# **SECTION 00901**

# **ADDENDUM NO. 1A**

This addendum modifies the Contract Documents dated November 9, 2021, for the San Lorenzo Valley Water District Glen Arbor Bridge Pipeline Replacement Project, and the work shall be accomplished in accordance with such modifications. This Addendum includes three (3) pages and one (1) attachment. Note that this Addendum #1A replaces Addendum #1, issued November 30, 2021, in its entirety.

# PIPE SUPPORT ELEVATION

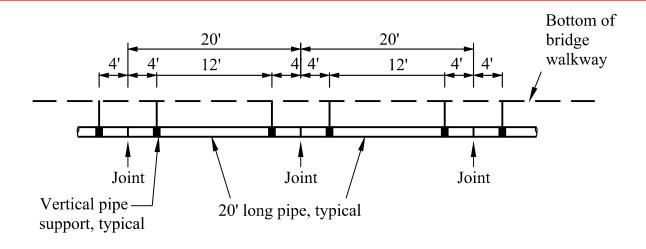
- 1.0 Detail 7 on Plan Sheet 2, Pipe Support Elevation, shows 18-foot pipe lengths. The Correct laying length is 20-feet. The attached exhibit shows revised vertical hanger spacing based on 20-foot laying length of pipe.
- 2.0 Detail 1 on Plan Sheet 2 calls for 45° angle fittings at each end of the Flex-tend located at the west end of the bridge. Due to a typographical error, Detail 1 on Plan Sheet 3 incorrectly identifies the same fittings as 15° angles. Detail 1 on Plan Sheet 2 is correct.

Adjust pipe supports so that they are not directly below railing posts

# ADDENDUM #1 THIS EXHIBIT REPLACES DETAIL 7/SHEET 2 OF ORIGINALLY PUBLISHED PLAN SET FOR GLEAN ARBOR BRIDGE WATER MAIN REPLACEMENT
